**SUBDIVISION COMMITTEE
METROPOLITAN AREA PLANNING COMMISSION**

**STAFF REPORT
(One-Step Final Plat)**

CASE NUMBER: S/D 98-97 - RANGE INDUSTRIAL ADDITION

**RE: Lot 1, Range Industrial Addition
1700 S. 151st Street West**

VICINITY MAP

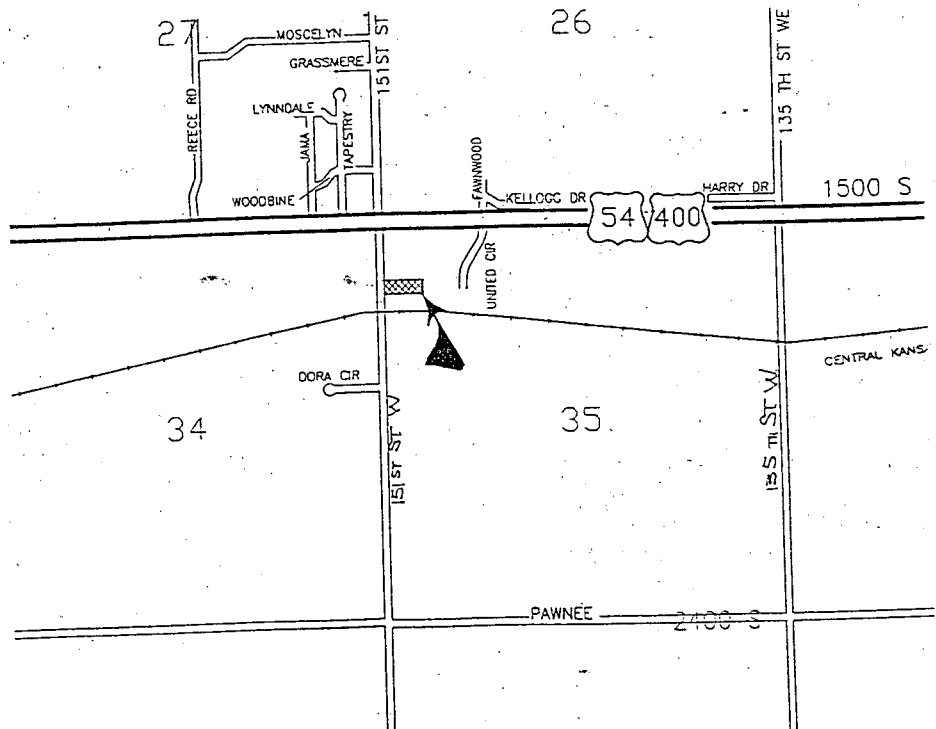
- A. Sanitary sewer appears to be available to serve this site. County Engineering needs to verify if any guarantees or easements are required.
- B. The site is currently served by a Rural Water District. The applicant shall contact this water district to determine the ability of this property being platted to connect to their water line and submit a letter from the water district regarding any requirements.

- C. County Engineering needs to comment on the status of the applicant's drainage plan.
- D. The final plat tracing shall denote complete access control except one opening along 151st Street West. The dedication of access controls shall be referenced in the plat's text.

- J. The lot depth-to-width ratio exceeds the 2.5 to 1 maximum allowed by the Subdivision regulations. Approval of this plat will require a modification to this provision.
